# CONSERVATION COMMISSION AGENDA

August 26, 2021

- Request: Issue an OOC.
3. **(7:25) Levingston Cove (Crystal lake) – NOI – park improvements – DEP File #239-901**
  - Owner: City of Newton Applicant: Luis Perez Demorizi, Open Space Coordinator

Drawing Title:  
**GRADING AND DRAINAGE PLAN ENLARGEMENT**

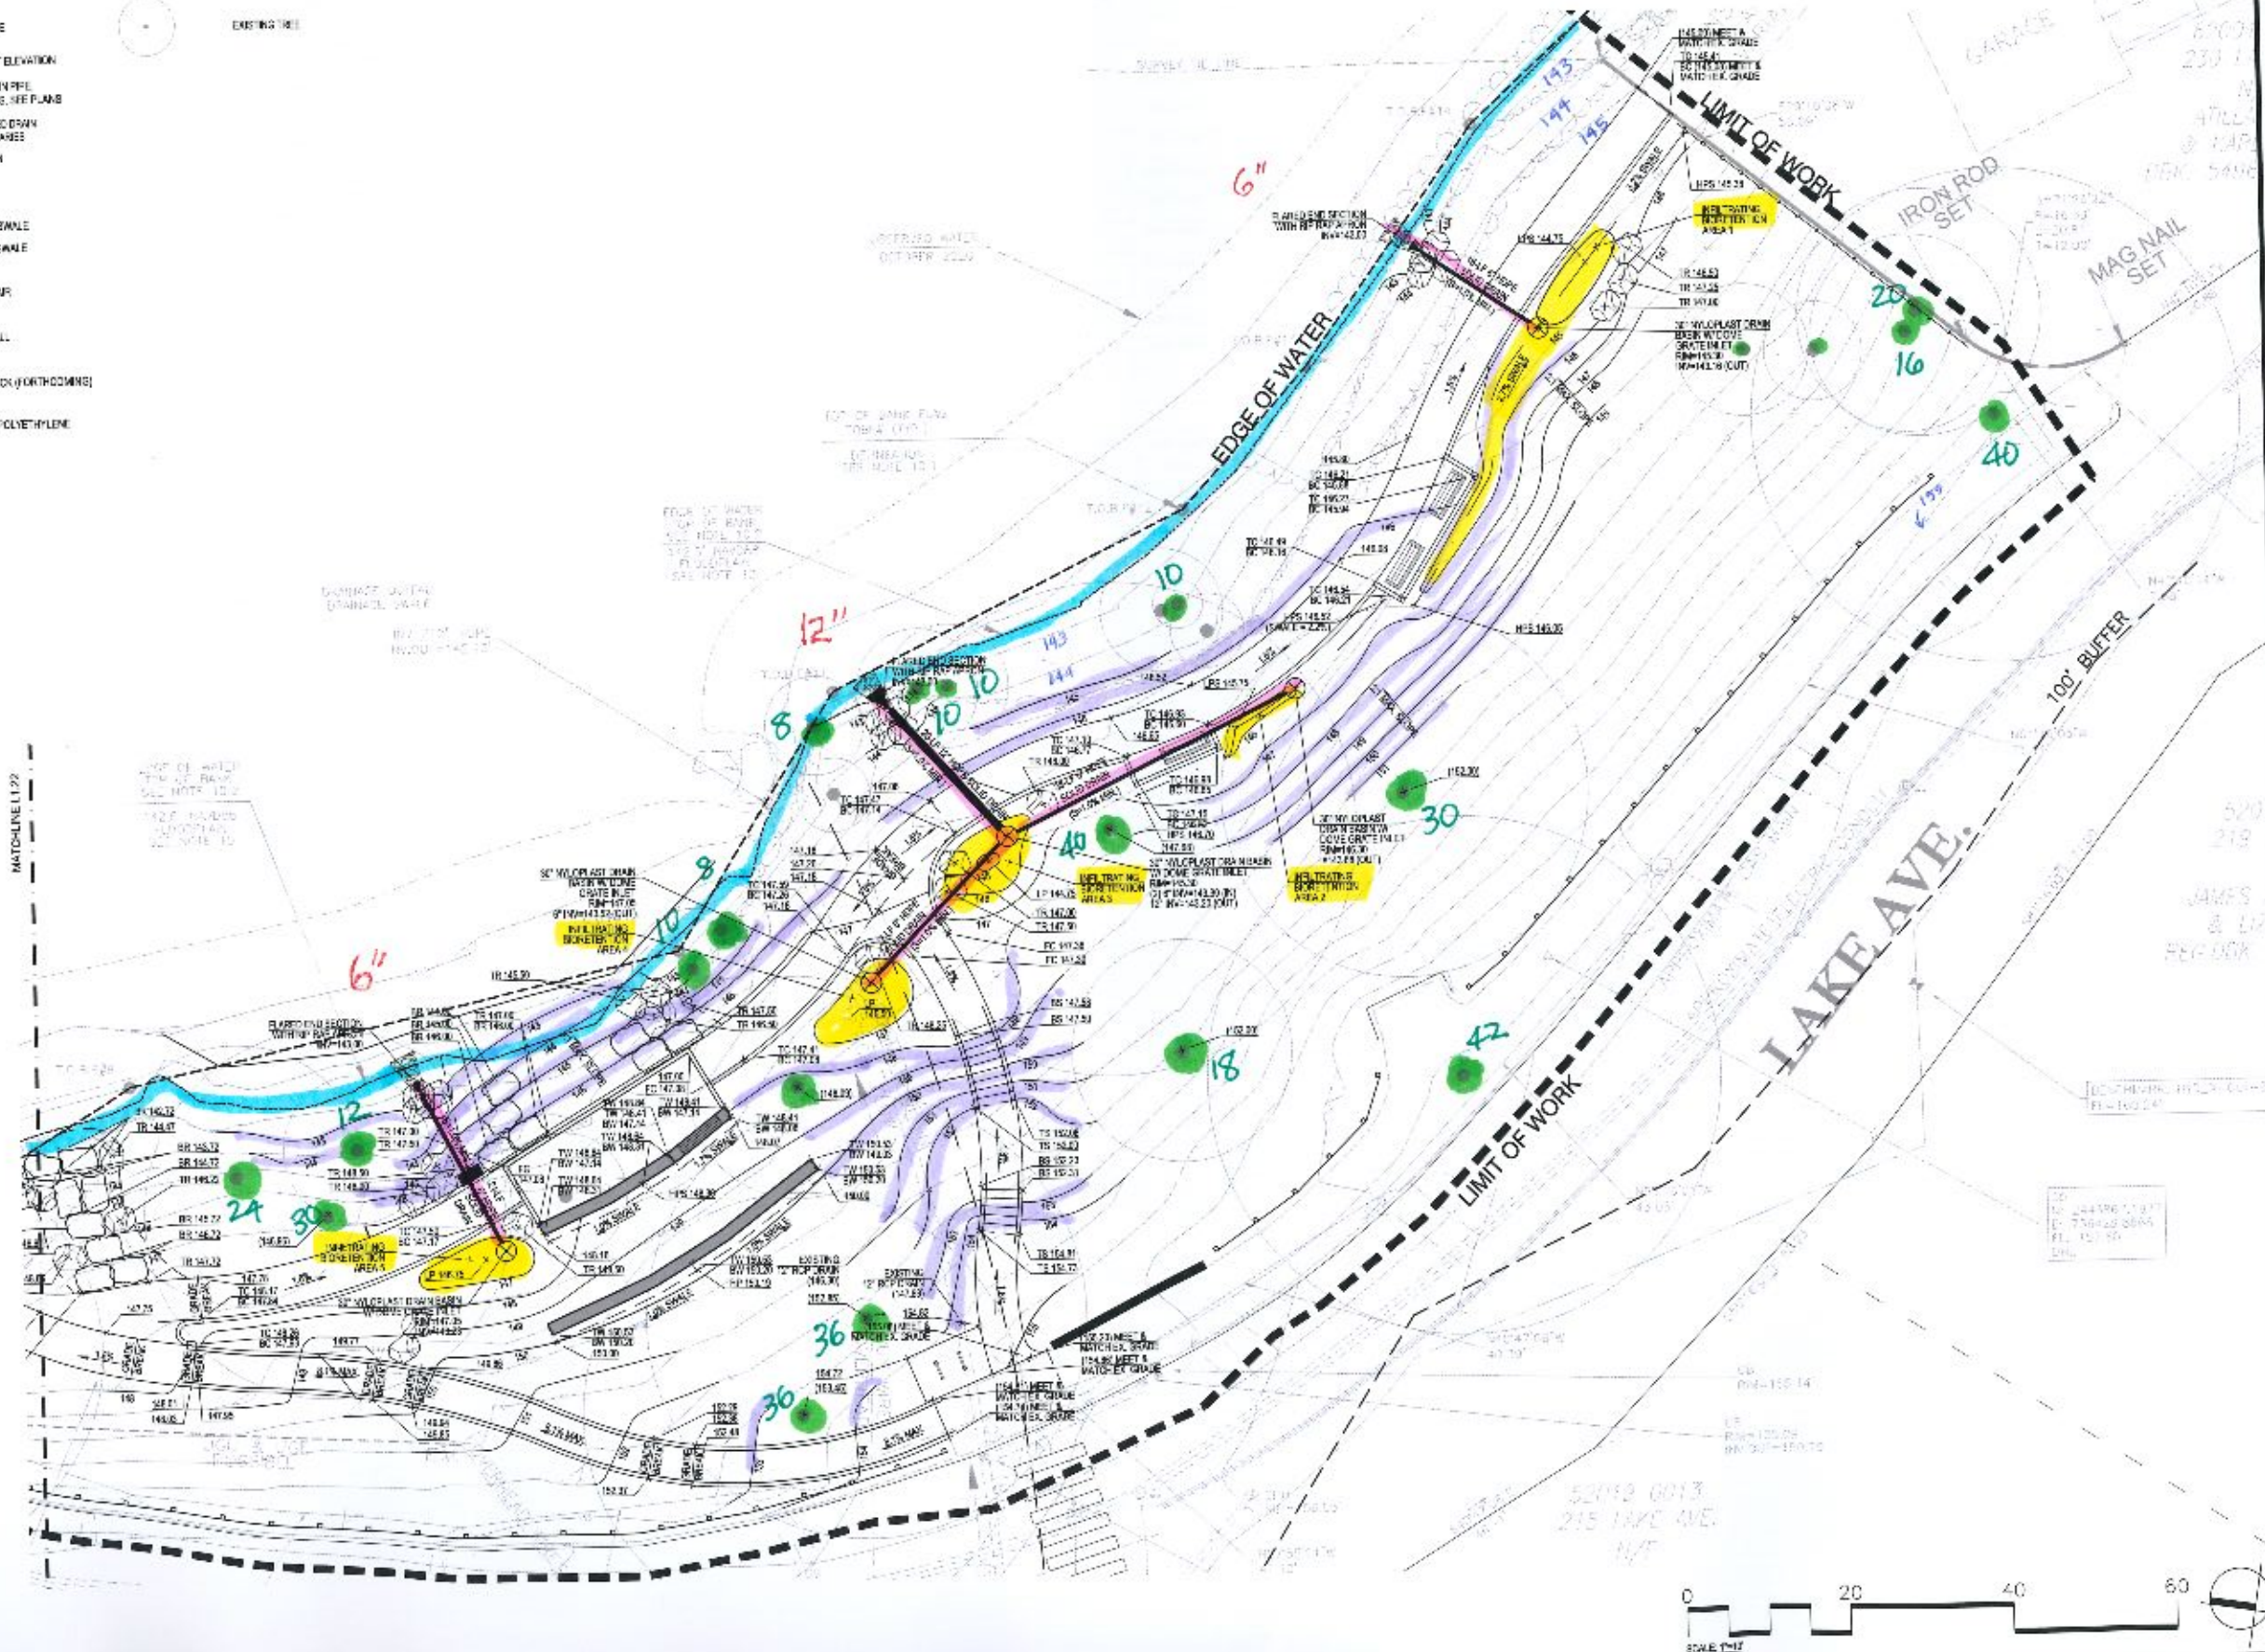
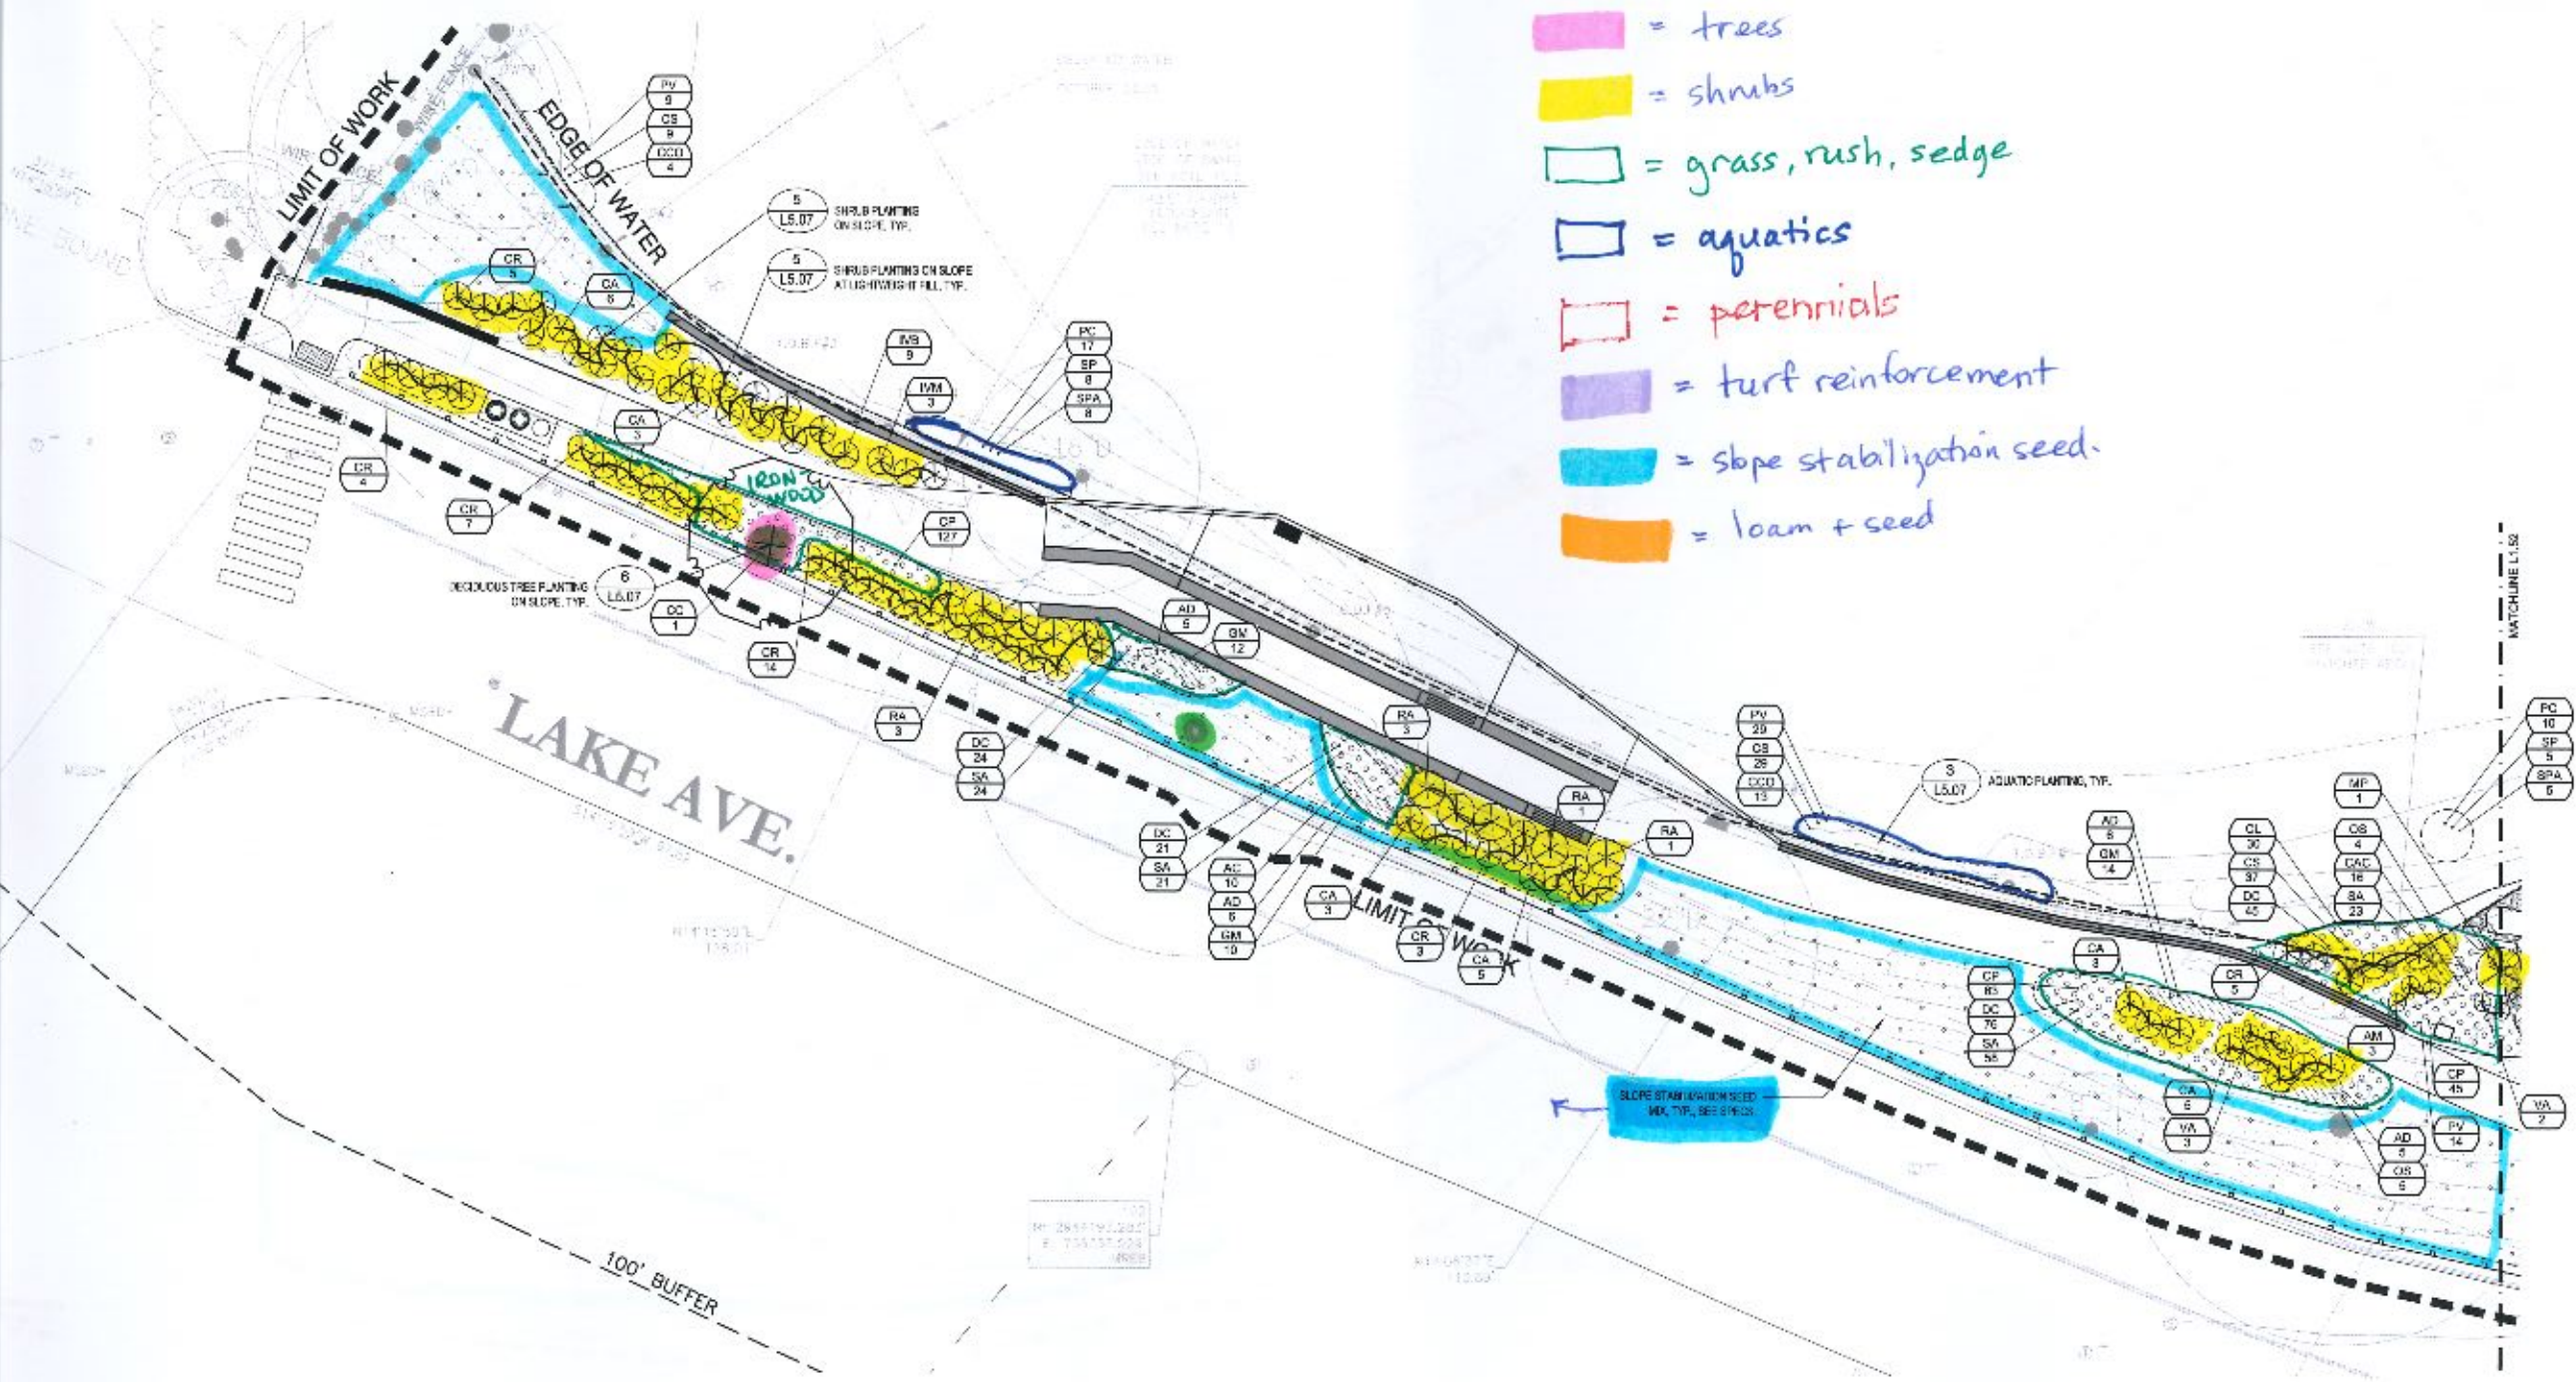
- In the narrative (and on the plans, as appropriate) the applicant should expand descriptions of anticipated processes such as:
    - Excavation
    - Stockpiling

- The applicant should clarify:
    - chapter 91 status,
    - anticipated timing of the work,
    - what work is proposed in the BVW (L1.11), and
    - tree protection (L1.11 and L5.00).

- What the "add alt – cofferdam with sandbags" (L1.10) pertains to? (stone veneer work?)
- What treatment methods and timing are planned for invasive species removal?

- What "synthetic turf reinforcement material" (narrative pg 2) is? (the 70-21-10 soil mixture?)
- Where the cross-sections A-D are located on the plan view?

- L5.07 – Turf Reinforcement detail. "tree mix"? (seed mix?) – please add the specs to the plan.
- S101 – "Section through pile cap" detail say "embed micropiles 6". Is that correct?

- S101 – is the cantilevered deck secured with bolts, not "deadmen"?
- Suggested plan and narrative changes:
  - Change in the narrative and L1.10 "straw wattles" to "staked silt fence and staked compost sock"

- The narrative states (confusingly) that the City Floodplain is at 149'. It is, on the CNVD. But that is 142.5' NAVD88, the datum of the plans. Therefore, the cut and fill information in the narrative pages 4&5 is inaccurate.

- Add cofferdam details.
  - Add the Turf Reinforcement specs to the plan.
  - Add dewatering information.
  - Add stockpiling locations.
- Staff Recommendations: Await responses to staff notes (and Commissioners' questions).
